ALERT SERVICE BULLETIN

206L-24-190

25 July 2024

- MODEL AFFECTED:** 206L, 206L-1, 206L-3 and 206L-4
- SUBJECT:** SWASHPLATE OUTER RING AND COLLECTIVE LEVER, CLEARANCE CHECK OF
- HELICOPTERS AFFECTED:** Serial numbers 45001 through 45153, 46601 through 46617, 45154 through 45790, 51001 through 51612, 52001 through 52496.
- COMPLIANCE:**
- PART I:** Within the next 100 flight hours or 180 days, whichever occurs first, after the release date of this bulletin.
- PART II:** After accomplishment of main rotor flight controls rigging.

Figure 1 - Collective lever assembly - clearance check

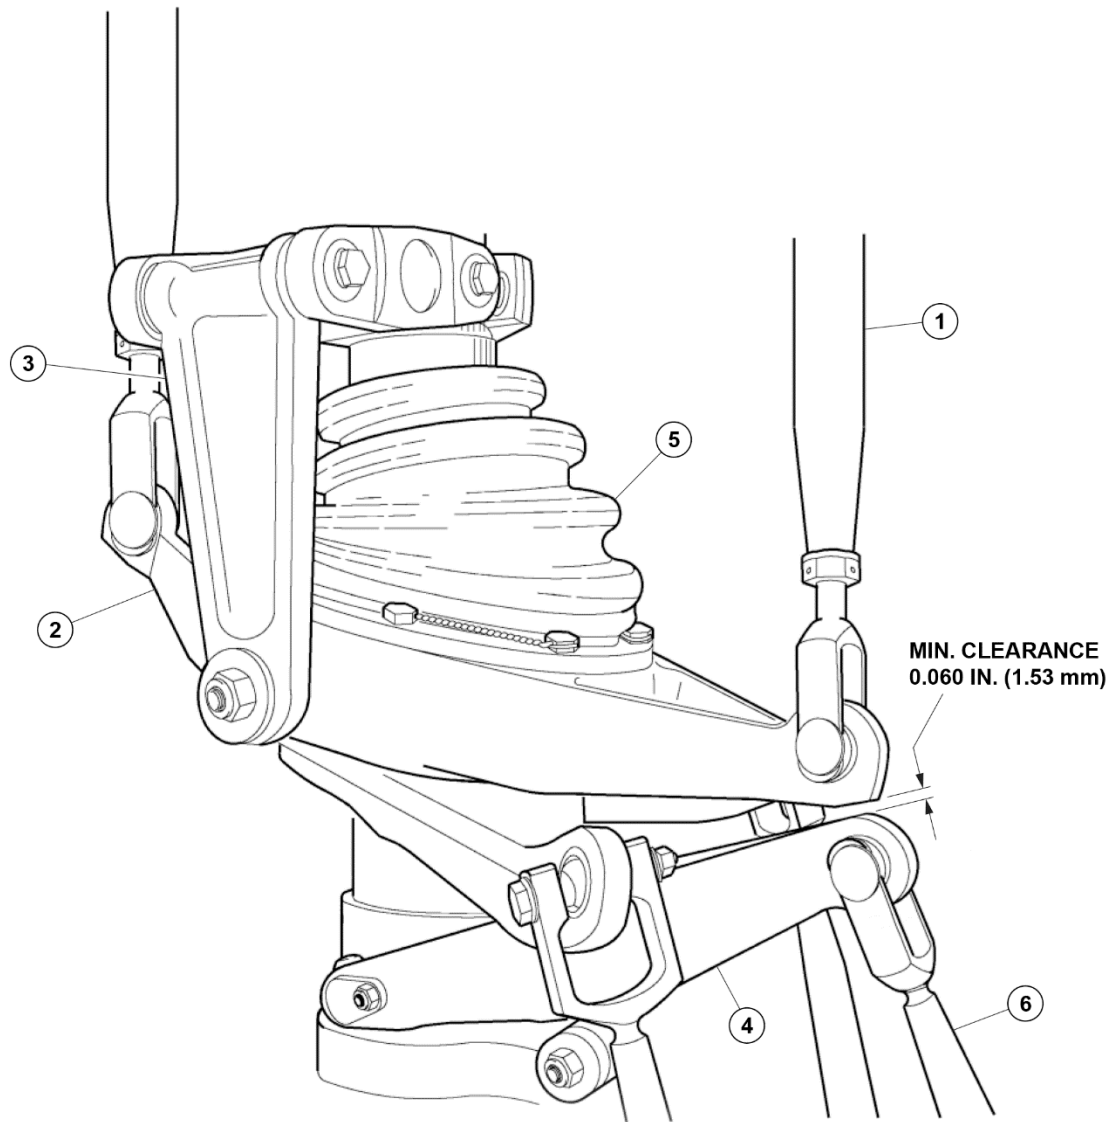
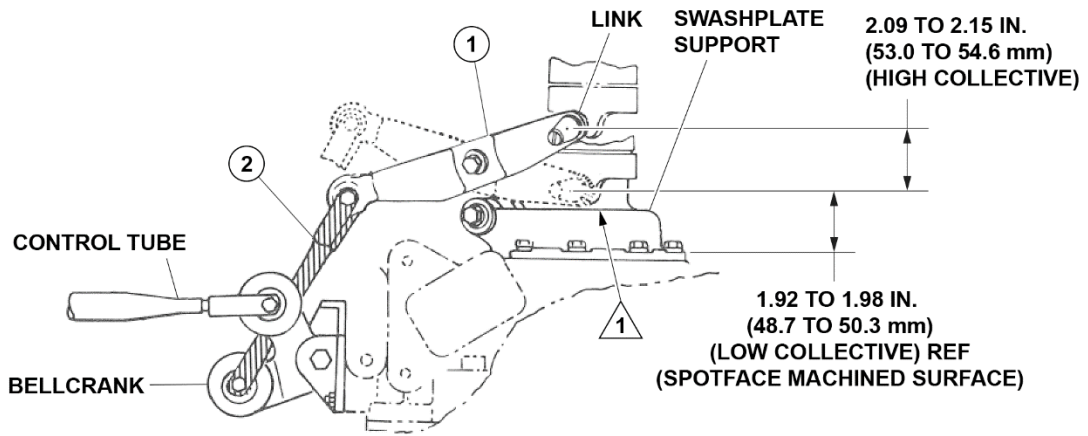
8. Slowly rotate the swashplate outer ring (2, Figure 1) until one of the pitch link attachment points is directly over the collective lever assembly (4).
9. Measure and record the clearance between the collective lever assembly (4) and the swashplate outer ring (2).

10. Repeat steps 8 and 9 for the second pitch link attachment point.

11. If clearance is 0.060 inch (1.53mm) or more at both pitch link attachment points, go to step 13.
12. If clearance is less than 0.060 inch (1.53 mm) at one or both pitch link attachment points, rigging of the collective and cyclic flight controls (Applicable 206L-MM, Chapter 27 or 67) is required prior to next flight.

- a. If minimum clearance of 0.060 inch (1.53mm) cannot be achieved at both pitch link attachment points after collective and cyclic controls rigging, it is acceptable to adjust the length of collective link 206-001-558 (6) to obtain the minimum clearance. Tolerance for rigging dimensions of the collective lever must be maintained (Applicable 206L-MM, Chapter 67 and Figure 2).

- b. If minimum clearance of 0.060 inch (1.53mm) cannot be obtained at both pitch link attachment points without exceeding collective lever dimensions tolerances, contact Product Support Engineering.

Figure 2 - Collective lever rigging dimensions

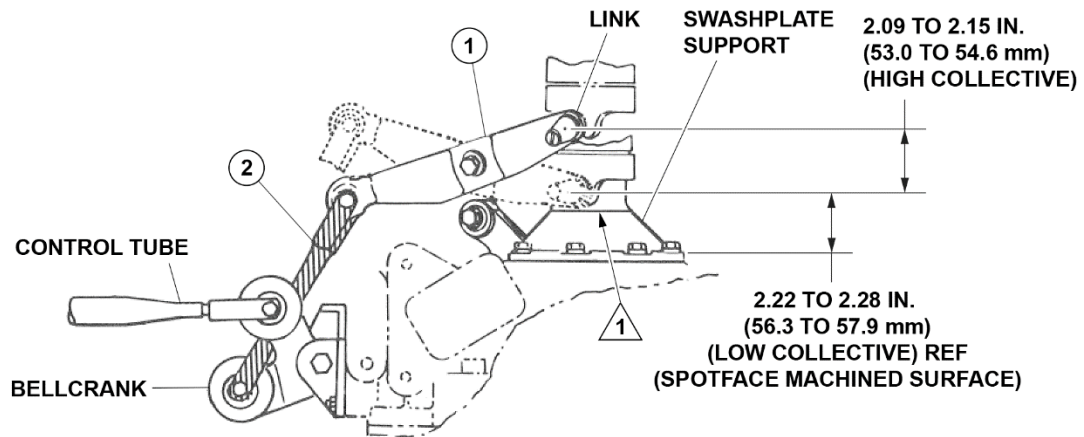
Aircrafts models 206L, 206L-1 and 206L-3 (S/N 51001 to 51307) who complied with Technical Bulletin 206L-91-153 MOD B or Service Instructions BHT-206-SI-2052 require different rigging dimensions than on the basic aircraft. Refer to OSN 206L-24-55 and Figure 2 for further details. Regardless of the aircraft rigging procedure and dimensions, the minimum clearance of 0.060 inch (1.53 mm) between the swashplate outer ring and collective lever applies.

1 With full down collective applied, ensure clearance exists between swashplate support and pivot sleeve after completion of collective and cyclic rigging.
